Docket No. 50-336

Millstone Nuclear Power Station, Unit No. 2
Proposed Revisions to Technical Specifications

Power Distribution Limits

January, 1984

FIGURE 3.2-3 Total Radial Peaking Factor Versus Allowable Fraction of Rated Thermal Power

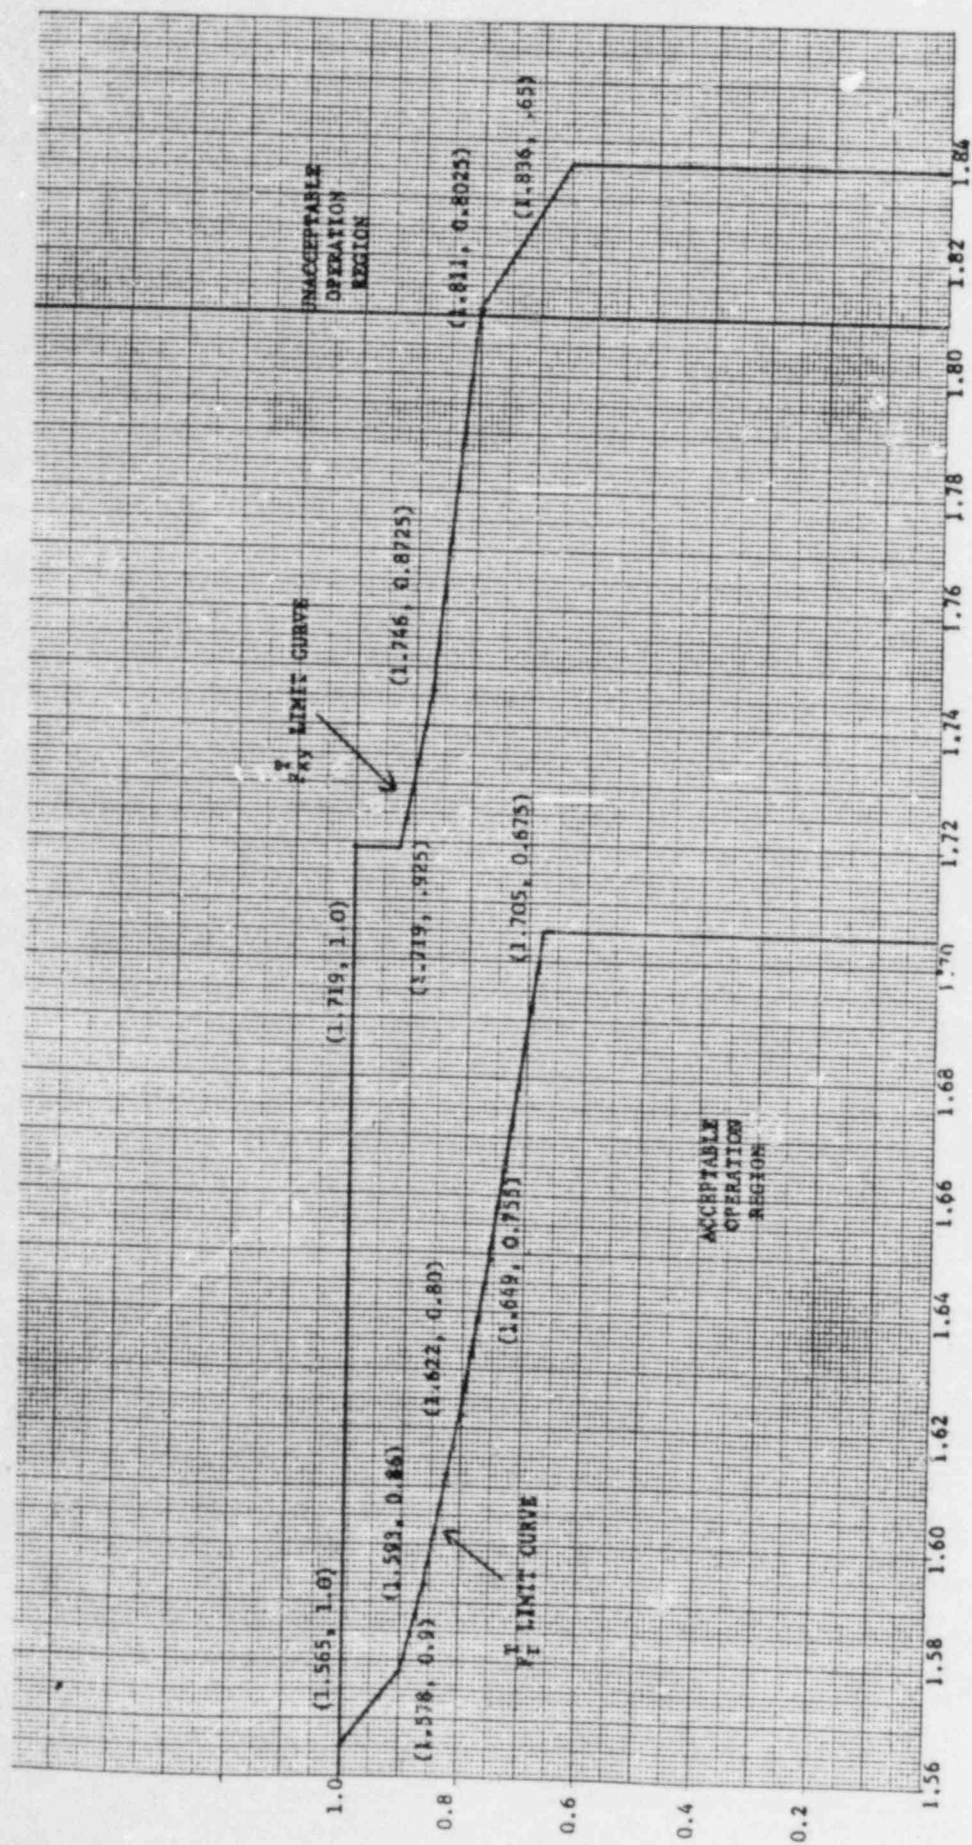
3.2.2 The calculated value of F_{xy}^T , defined as $F_{xy}^T = F_{xy} (1+T_q)$, shall be limited to ≤ 1.719 .

With $F_{xy}^T > 1.719$, within 6 hours either:

- a. Reduce THERMAL POWER to bring the combination of THERMAL POWER and F_{xy}^T to within the limits of Figure 3.2-3 and withdraw the full length CEAs to or beyond the Long Term Steady State Insertion Limit of Specification 3.1.3.6; or
- b. Be in at least HOT STANDBY.
